CERTIFICATE OF APPROPRIATENESS

Property: 714 Woodland Street, lot 3, tract 4A, block 36, Woodland Heights Subdivision. The property includes a historic 2,491 square foot, one and half story wood frame single-family residence situated on a 7,500 square foot (75' x 100') interior lot.

Proposal: Alteration – The applicant received partial approval at the November 2014 HAHC meeting for alterations to the existing front porch. The applicant proposed to apply a brick facing to the existing concrete porch deck and concrete steps, the brick facing was denied. The applicant has revised the proposal and is now requesting approval to construct wing walls on the side of the concrete steps and apply a brick facing to the brick steps.

NORTH ELEVATION – FRONT FACING WOODLAND STREET
EXISTING

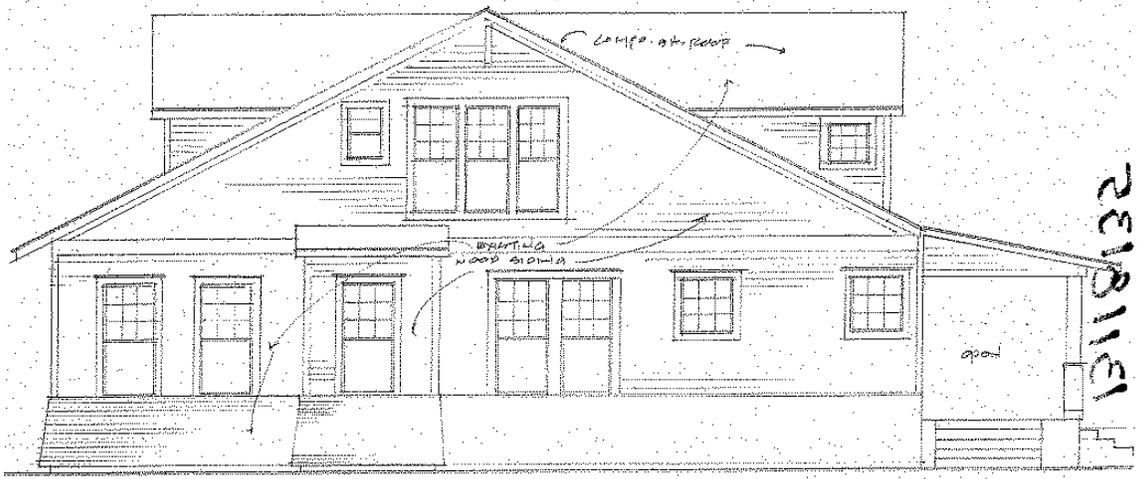
Approval of the brick wing walls on the side of the concrete steps located on the north and east elevations.

Denial of the application of the brick facing to the front porch steps.

<i>The application of the brick facing to the existing concrete steps creates a false sense of history by introducing an architectural feature that has never been present on the residence.</i> | |

<i>Brick facings on steps are not typical of contributing residence in the district. The typical condition found in the district is either wood porch decks with either wood or concrete steps or a concrete porch deck with concrete steps.</i> | |
